i960[®] RM/RN I/O Processor

Specification Update

January 1999

Order Number: 273164-003

7. Data Corruption Occurs when Transfer Data Value Matches the Memory Mapped Register (MMR) Addresses of the DMA Channels

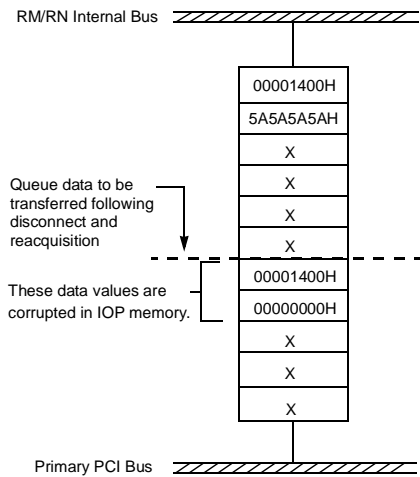
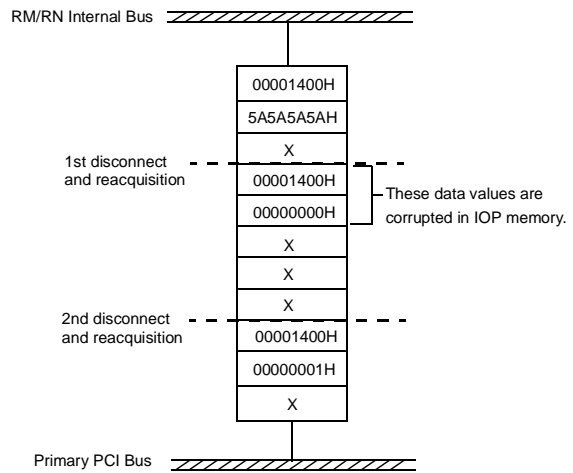
Problem: This problem appears across all 3 DMA channels: DMA Ch-0, Ch-1, and Ch-2. If the transfer data value falls within the MMR address range of the active DMA channel (1400H - 143FH for Ch-0, 1440H - 147FH for Ch-1, and 1480H - 14FFH for Ch-2), data corruption will occur.

Examples on page 14 describe the error condition.

Assumption: DMA channel 0 is used to transfer data from PCI to IOP memory.

Implication: Data corruption results when the data value matches the MMR address range of the active DMA channel.

Workaround: There are two possible workarounds for this errata:

- Use the Primary Address Translation Unit (PATU) to transfer data from Primary PCI to IOP memory and Secondary Address Translation Unit (SATU) to transfer data from Secondary PCI to IOP memory.
- Configure the Memory Controller Unit to execute in 32-bit mode. For further information, refer to Section 13.3.3 on page 13-14 of the *i960® RM/RN I/O Processor Developer's Manual* and to Table 4 in the 80960RM/RN I/O processor datasheets.

2. **Hooking up the SDRAM Clock Enable Outputs (SCKE0 and SCKE1) from the i960® RM/RN I/O Processor to the Clock Enable Inputs on the SDRAM DIMM in a Battery-Backup Application**

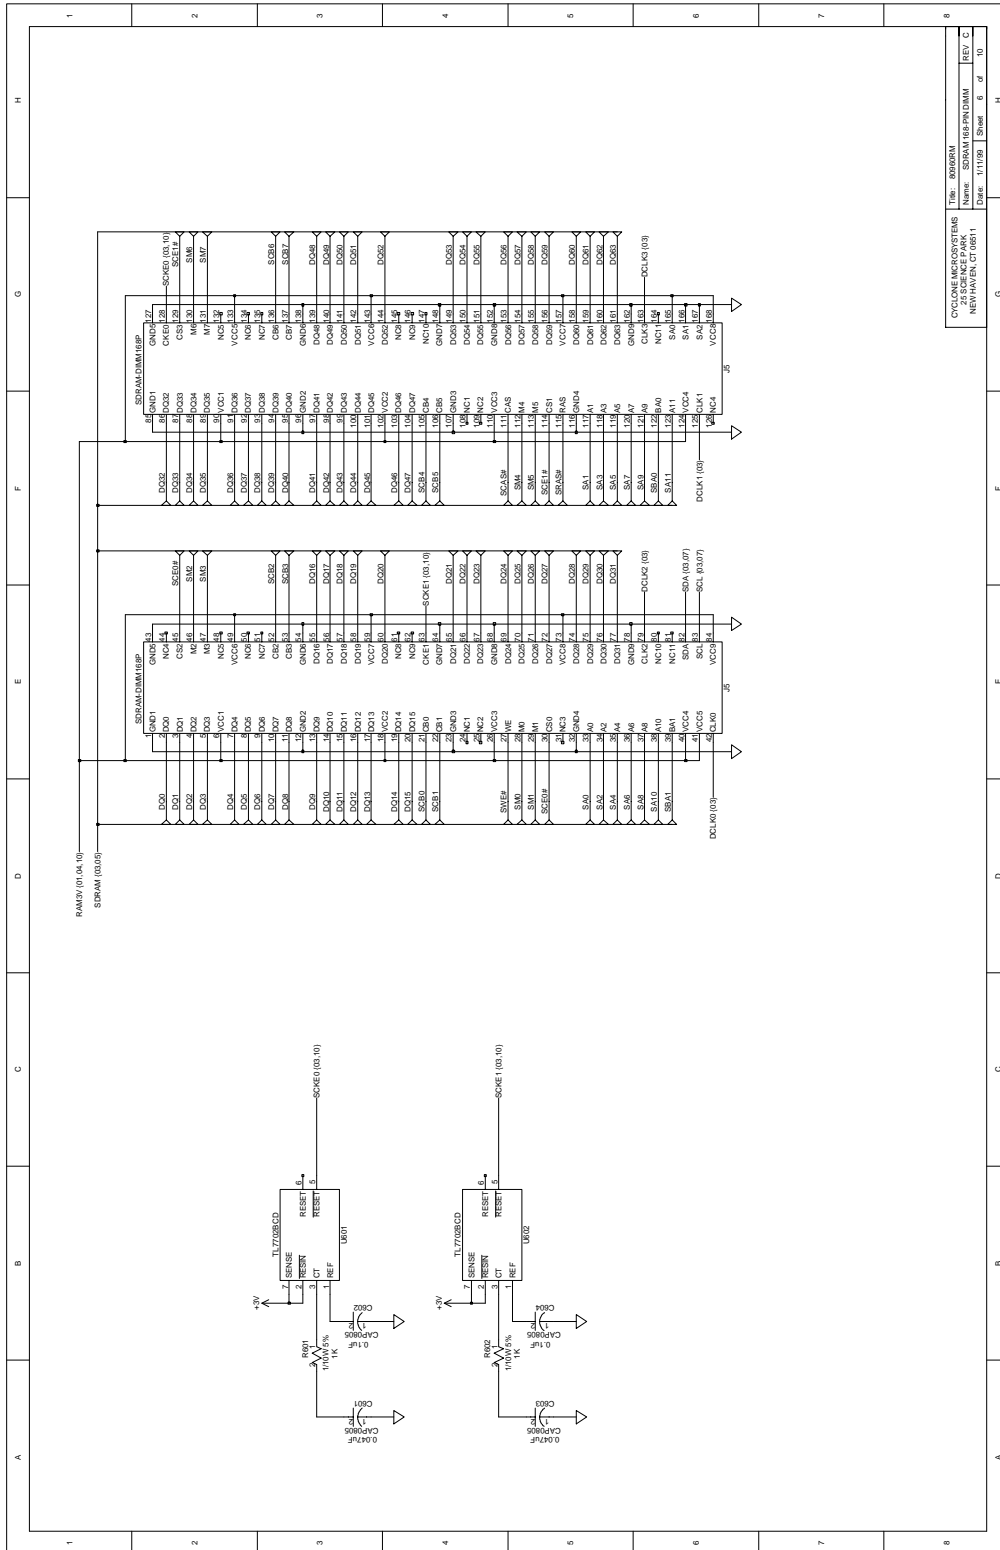
Problem: During the power-up reset sequence, the SDRAM devices occasionally enter a pseudo, self-refresh mode. This causes a lock-up condition on the SDRAM device. Normal operation of the SDRAM device which includes the SDRAM initialization sequence does not clear the lock-up condition.

Workaround: Ensure that the Clock Enable Inputs to the SDRAM DIMM are held low during power-up. This is accomplished as shown in the following circuit schematics (Sheet 6 – 80960RM schematics and Sheet 6 – 80960RN schematics in *i960® RM/RN I/O Processor Design Guide*).

1. Page 1 of 80960RM Schematics and Page 1 of 80960RN Schematics

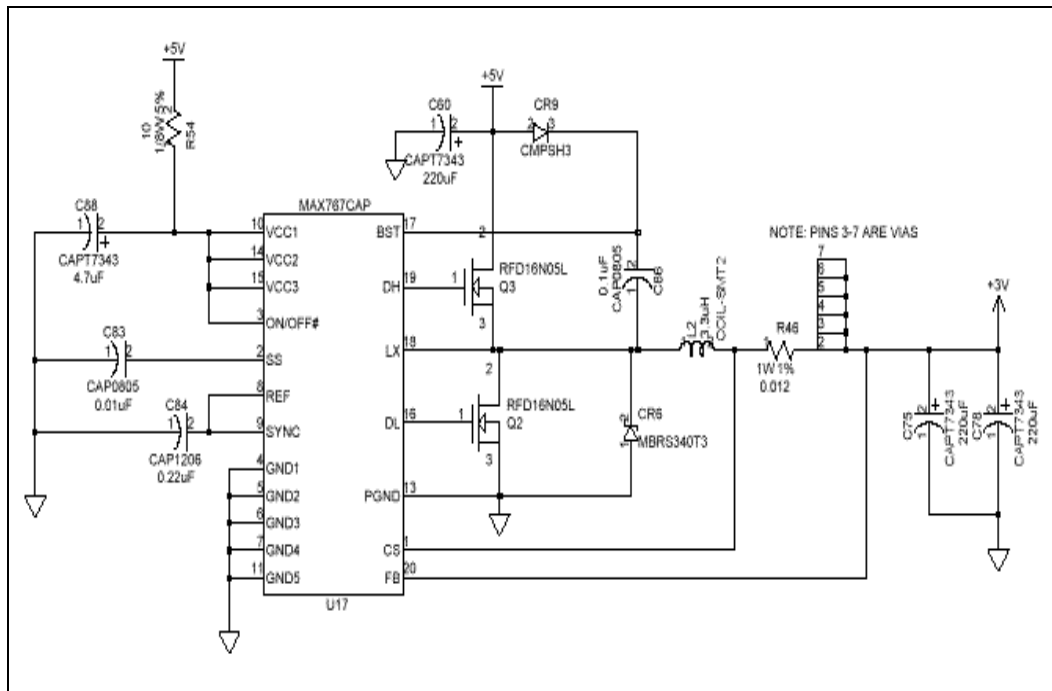
Issue: FETs Q2 and Q3 have had pinout changes as shown below.

2. Page 1 of 80960RM Schematics and Page 1 of 80960RN Schematics

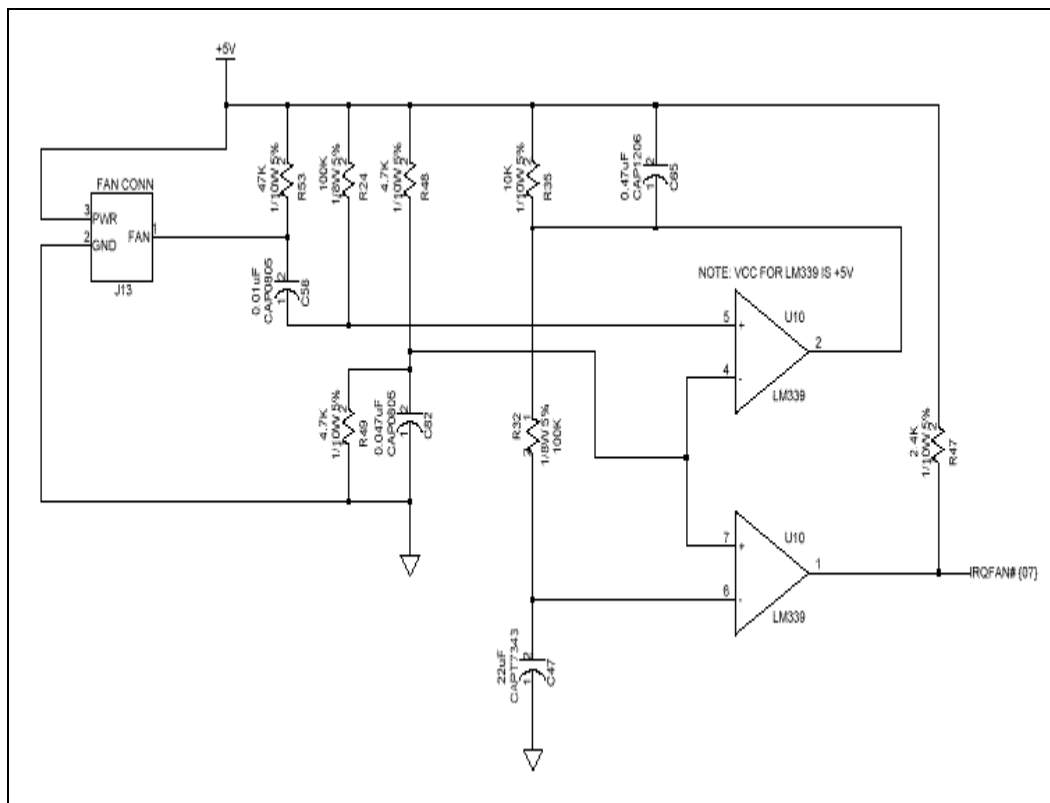
Issue: The fan connector, J13, has been changed by the manufacturer as shown below.
